Vendor Questions

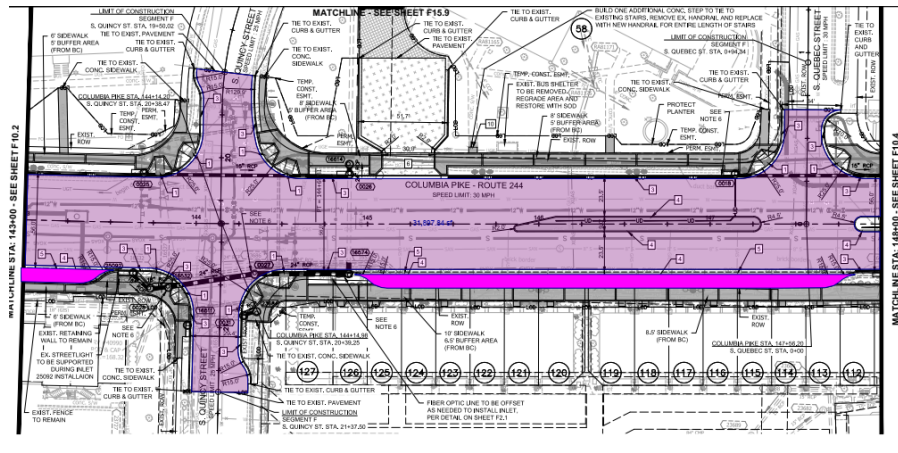
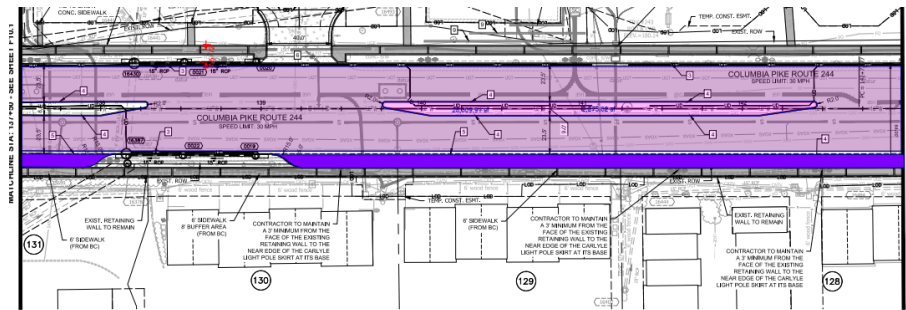
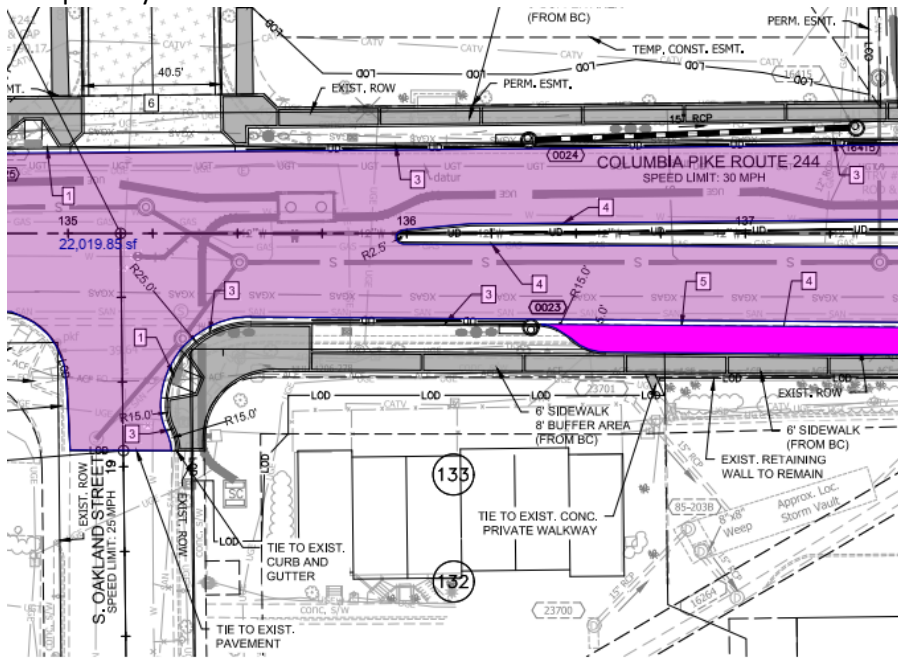
75. The opaque colors in the snapshots below are shown as concrete on the plans; however, it appears its intention is for a parking lane. If this is the case, and its true intention is for a parking lane, then the quantity for concrete will be skewed as the intended line item should be asphalt.

Response: Refer to Columbia Pike Onstreet Parking Section detail on Sheet F3.3 for Parking Lane. Please use item # 03100-C2-00240 of the revised pricing sheet for this work.
